Our Ref: A16195B

**Re: Alternative solution options regarding access for the development at
Lot 5 DP 593628 & Lot 3 DP 1103503
46a & 46-66 O'Connell Street, Caddens**

Travers bushfire & ecology (TBE) has been engaged to provide a review of the development proposal (as lodged with Council in January 2017) in relation to the public road access design (width and parking provisions) and its compliance with the RFS policy document entitled *Planning for Bushfire Protection 2006 (PBP)*.

Figure 1 – Ownership and access design

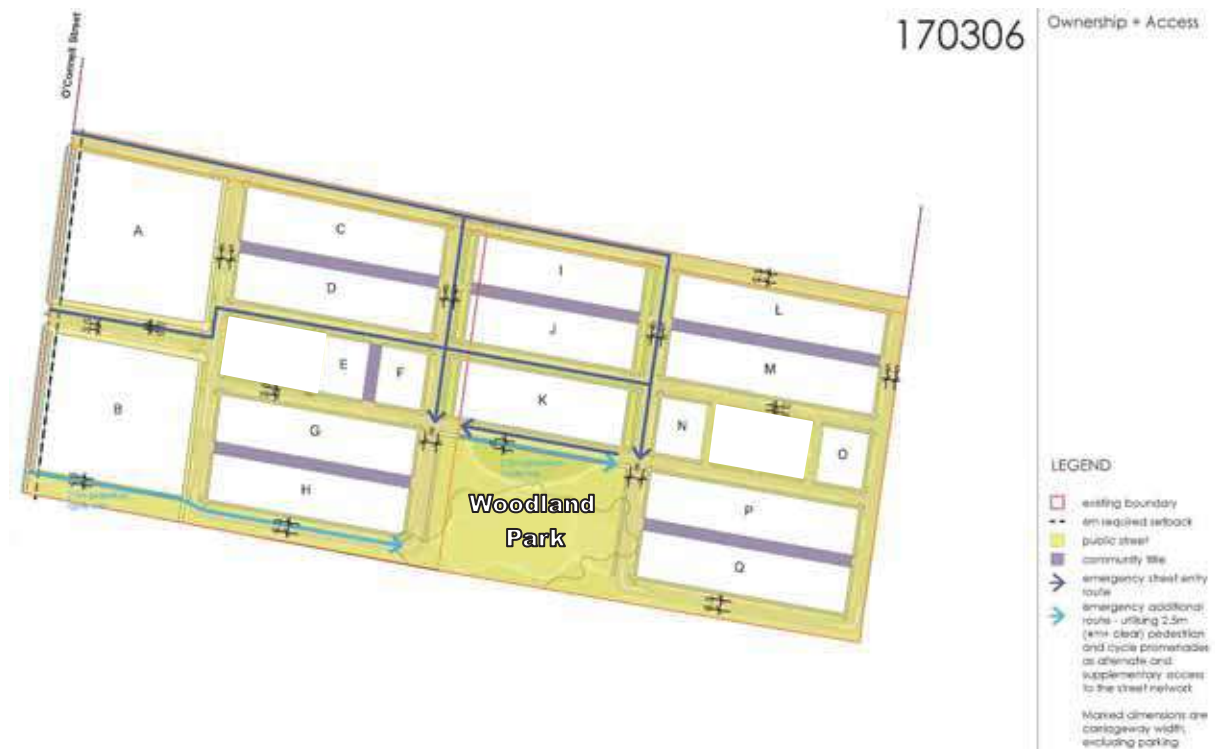
Based on the location of the bushfire hazard and overall traffic flow there are a number of roads within the development which are considered ‘essential’ for firefighting operations and/or safe evacuation of residents. These roads are required to provide safe operational access for emergency services. These essential roads are identified in Schedule 1 (attached) and applies to all public streets (depicted yellow in Figure 1 above).

Proposed ‘lanes’ are private access lanes and are held in community title ownership (marked purple in Figure 1). They retain their current proposed width of 4m (one-way).

Figure BO1 (proposed change) – Main Street

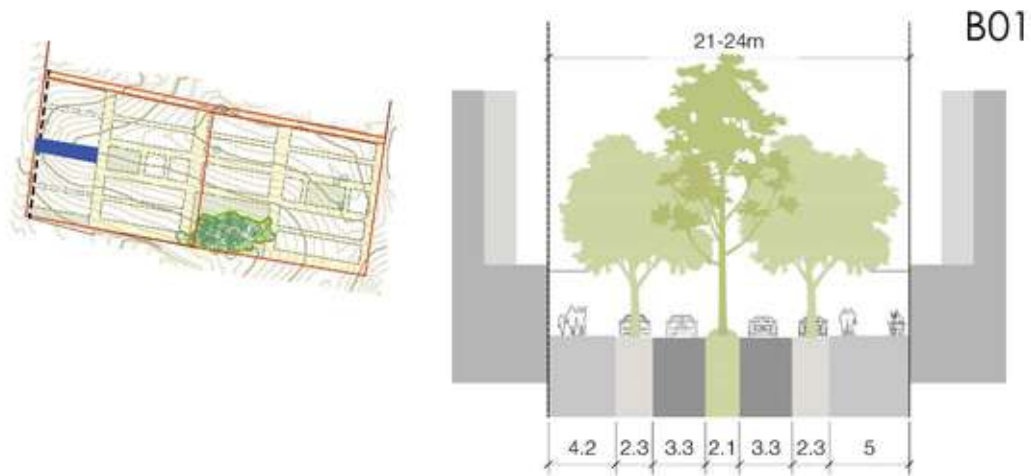
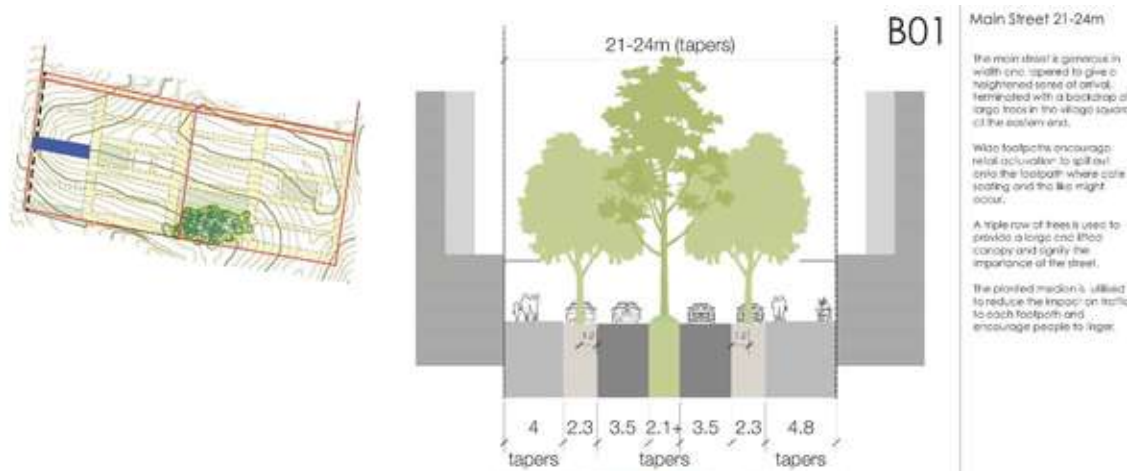
As depicted in blue below this is a split single lane road originally provided with a 3.3m wide lane width.

This road is considered an essential road and has been amended to provide a 3.5m lane width with a vertical clearance of 4m as required by PBP. Parking has been retained at 2.3m.

Figure B02 (proposed change) – Paired Street

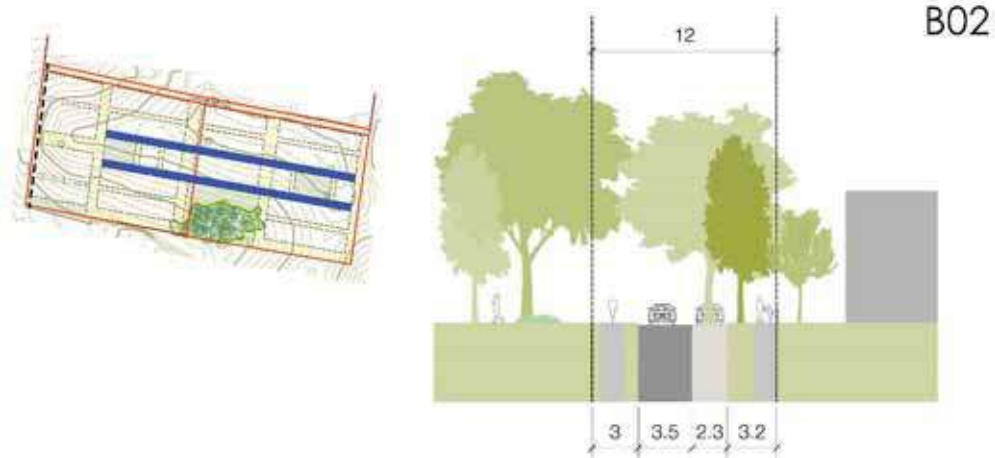
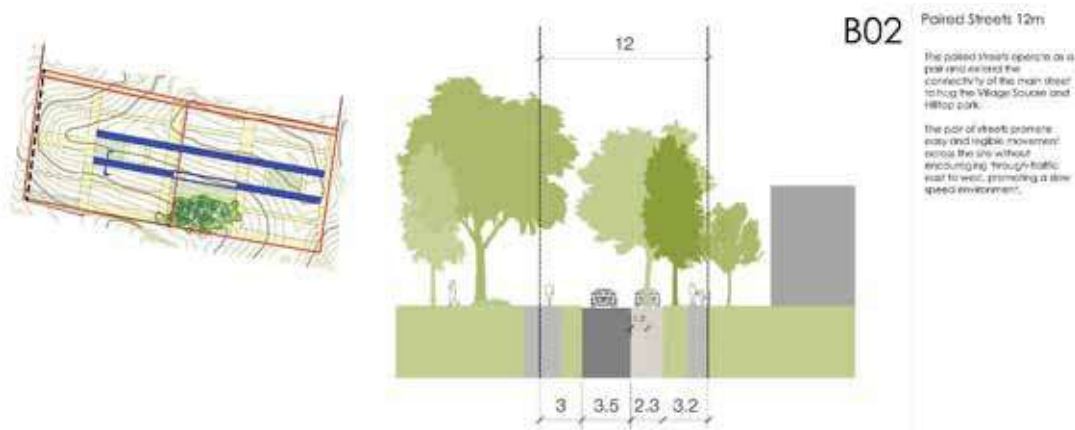
As depicted in blue below this is a single lane road originally provided with a 3.5m wide lane width.

The portion of this road depicted in blue below (not considered a perimeter road) complies with the acceptable solutions of PBP and has therefore retained the 3.5m width.

Figure B02b (proposed change) – Paired Street

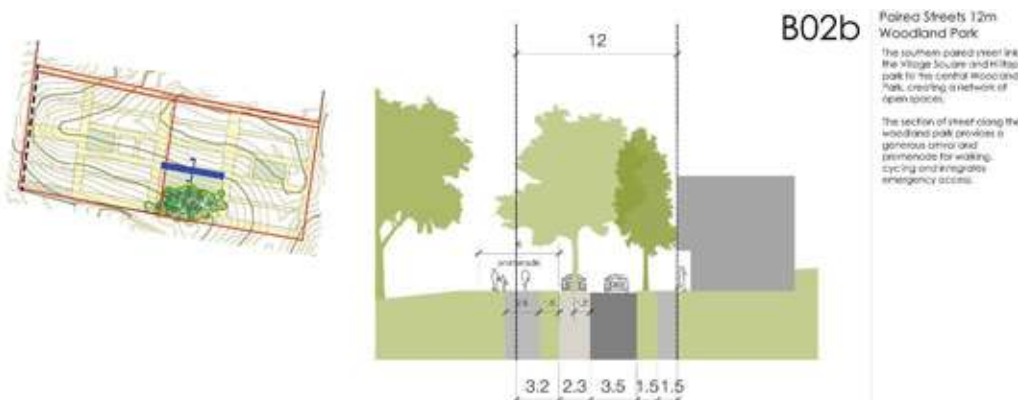
The portion of road adjacent to the woodland park is considered a 'perimeter road'. This portion of road has been amended as per Figure B02b below.

Whilst the proposed road will retain its 3.5m one-way width for public access an additional emergency access route will be provided to the south (adjacent to the hazard) to run parallel with the woodland park. This emergency access route will include a 2.5m wide cycleway with a 1.5m wide grassland verge (designed to support a 15 tonne fire truck). This provides a total width of 4m. The strip park will provide additional sufficient clearance to allow fire fighter access and room to work around the vehicle in the unlikely event of a bushfire.

Figure B03 (proposed changes) – North-South Streets

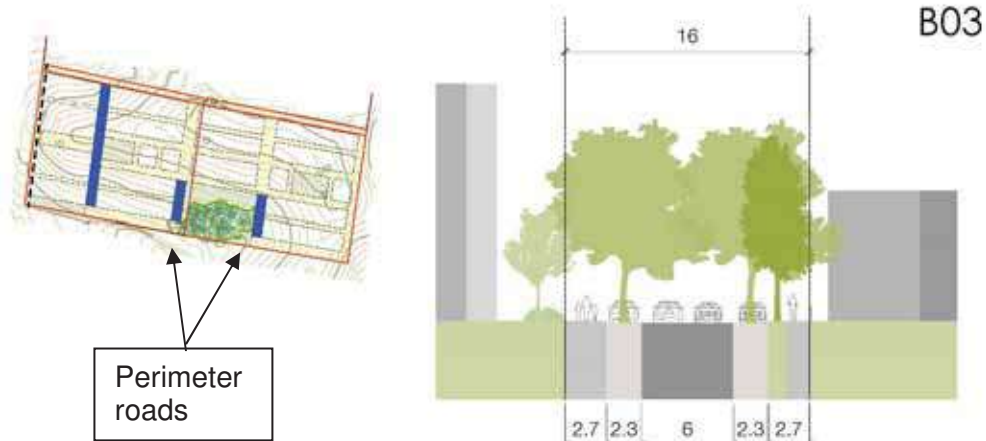
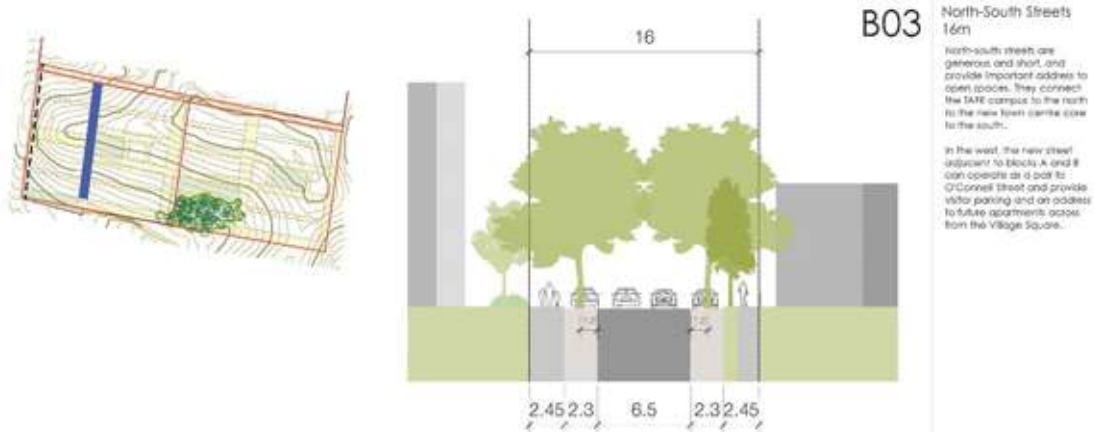
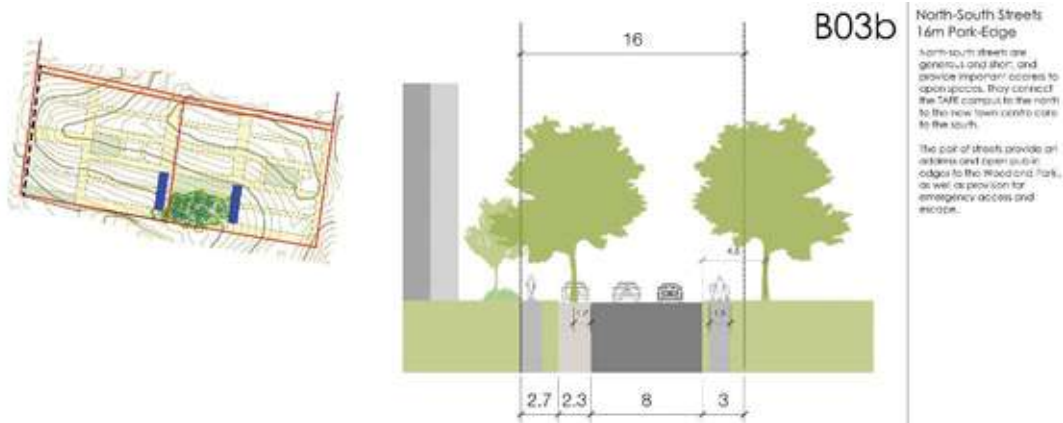
As depicted in blue below this is a two way road originally provided with a 6m wide lane width.

The western road is considered an essential road and has been amended to provide a 6.5m width with a vertical clearance of 4m as required by PBP. Parking can be retained at 2.3m.

The two north-south perimeter roads (B03b) have been amended from 6m to 8m in compliance with the perimeter road requirements of PBP. The plans have been changed to ensure no parking on the hazard side of the roads with the services (hydrant) located on this side to ensure accessibility to reticulated water for fire suppression.

Figure B04 (proposed changes) – North-South Streets

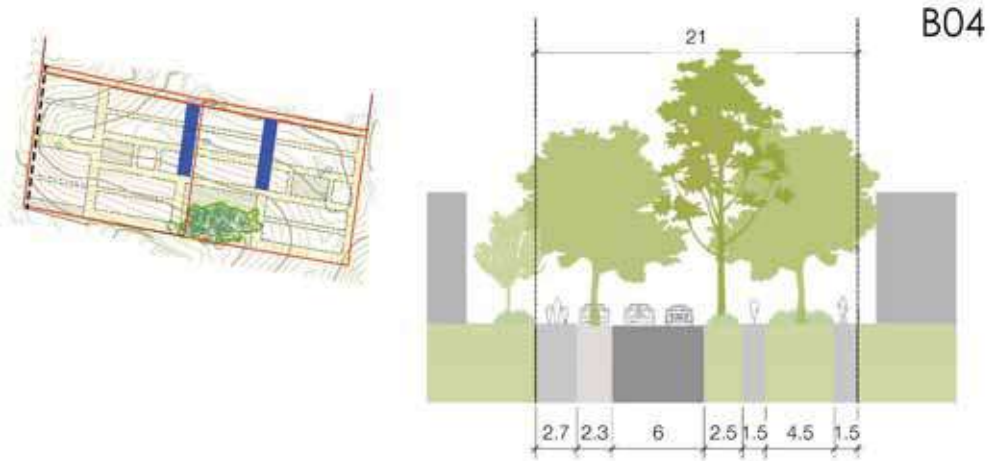
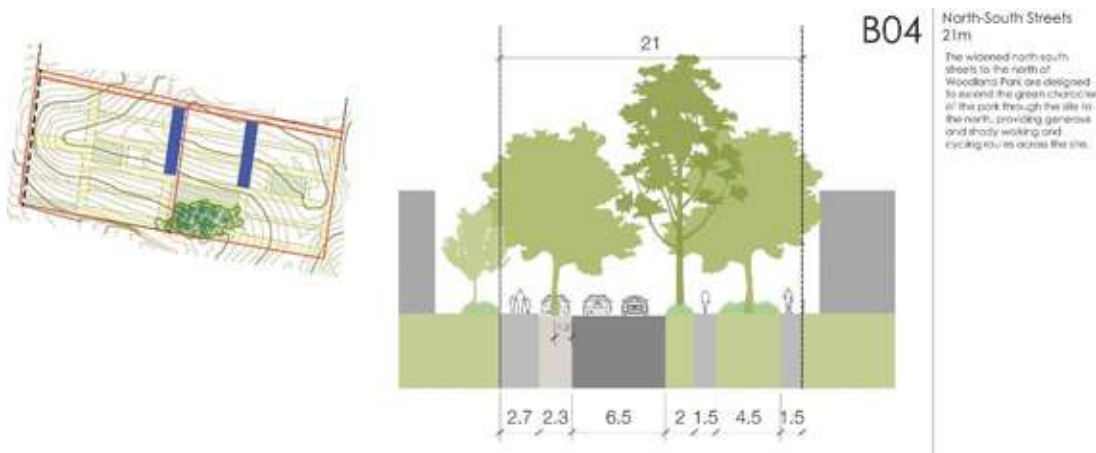
As depicted in blue below this is a two way road originally provided with a 6m wide lane width.

These roads are considered essential roads. The entire road length has been amended to provide a 6.5m lane width in compliance with PBP. Parking is retained at 2.3m on one side only.

Figure BO5 (proposed changes) – South Edge Street

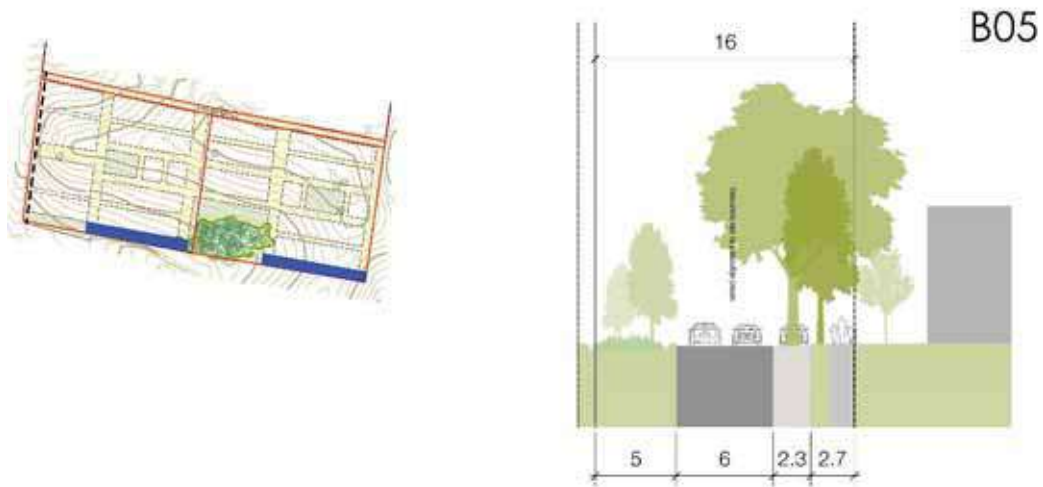
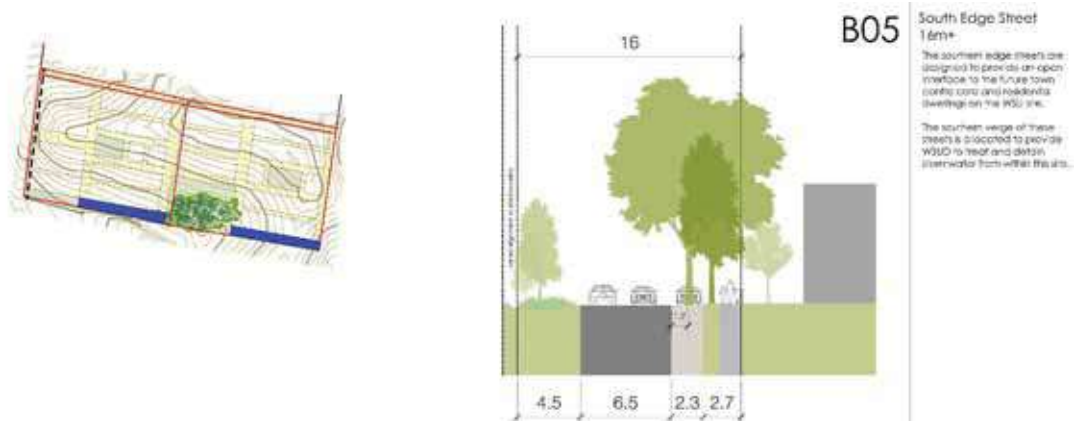
As depicted in blue below this is a two way road originally provided with a 6m wide lane width.

These roads are considered essential roads and have been amended to provide a 6.5m lane width in compliance with PBP. Parking is retained at 2.3m.

Figure B06 (proposed changes) – North Edge Street

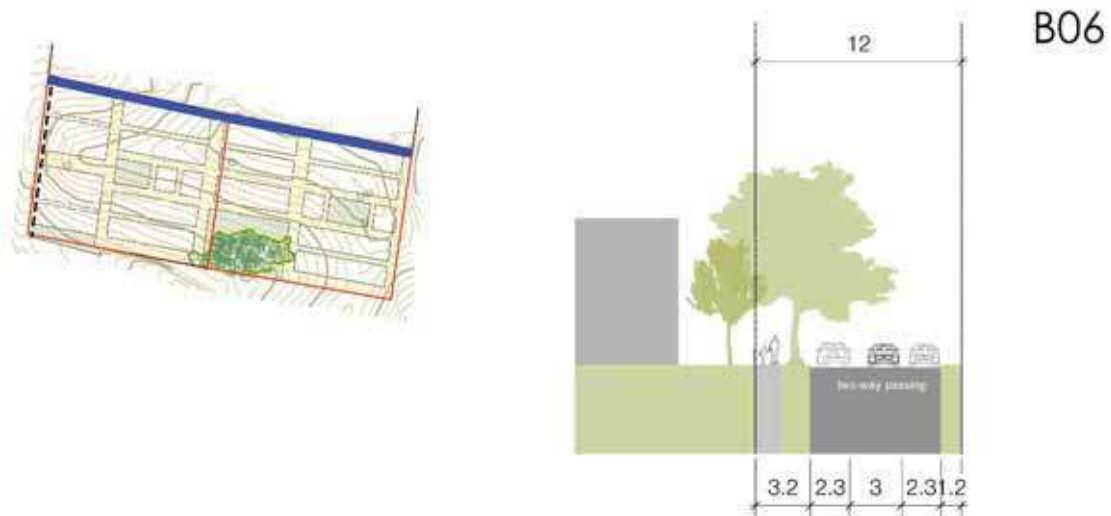
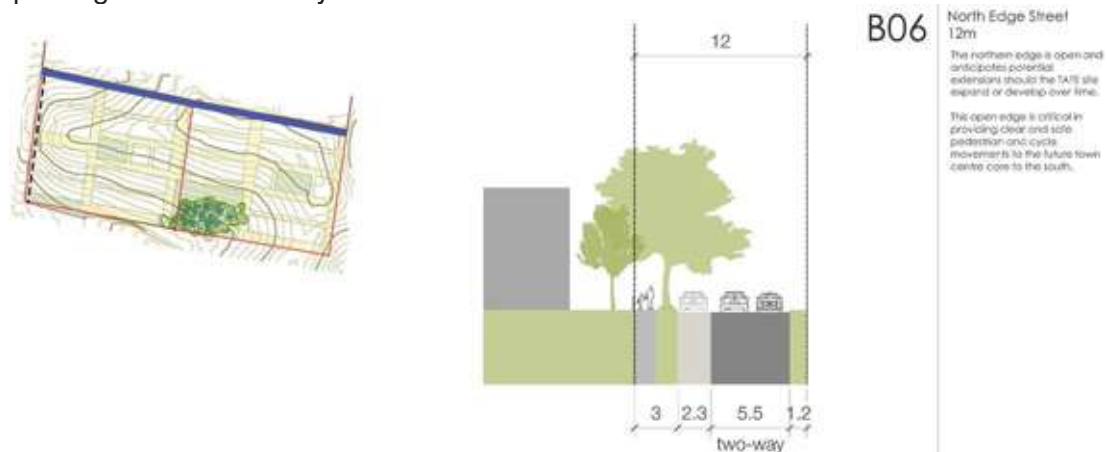
As depicted in blue below this is a two way road originally provided with parking on each side. The design of the two way passing road was to allow cars travelling in opposite direction to pass each other in the outer 2.3m (i.e. $2.3 + 3m = 5.3m$). The outer 2.3m was also used for parking which would hinder passing opportunities.

This road does not comply with the acceptable solutions of PBP (i.e. 6.5m width). An alternative solution has been proposed based on the low bushfire risk. Road B06 for the most part, is located over 150m from bushfire prone vegetation. The bushfire affectation on this 5.5m road is considered negligible.

The radiant heat impact on this road is calculated at $1.65kW/m^2$ which is considered a very low threat category. As a result it is unlikely that fire fighting vehicles will need to utilise this northern road whilst residents are evacuating. Fire fighters will be provided with a further two (2) egress routes through the centre of the property or via the additional emergency access route in the south. It is unlikely that residents will need to evacuate from the northern portion of the site based on the very low bushfire risk. However it is recommended that roll top kerbs are provided on each side of B06 to allow a firetruck to readily mount the kerb and pass any obstructing vehicle on the road (although this is unlikely).

The entire road length as depicted below has been amended to provide a 5.5m lane width plus parking on one side only.

Figure B07 (proposed changes) – East Edge Street

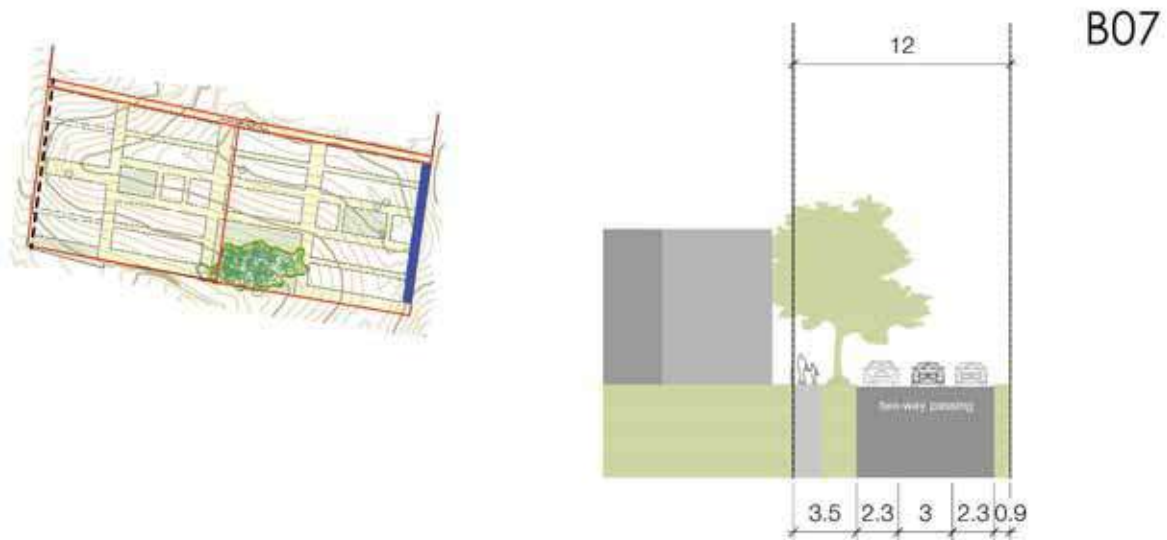
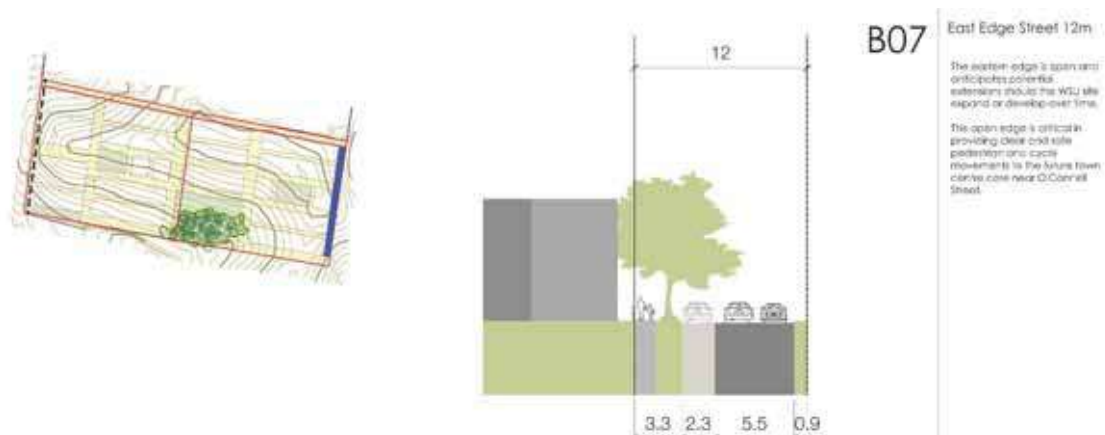
As depicted in blue below this is a two way road originally provided with parking on each side (similar to B06 above). The design of the two way passing road was to allow cars travelling in opposite direction to pass each other in the outer 2.3m (i.e. $2.3 + 3m = 5.3m$). The outer 2.3m was also used for parking which would hinder passing opportunities.

As discussed above for road B06, road B07 is located over 150m from bushfire prone vegetation. The bushfire affectation on these 5.5m roads is considered negligible.

As depicted in the figure below the entire road length has been amended to provide a 5.5m lane width plus parking on one side only.

It is recommended that roll top kerbs are provided on each side of B07 to allow a firetruck to readily mount the kerb and pass any obstructing vehicle on the road (although this is unlikely).
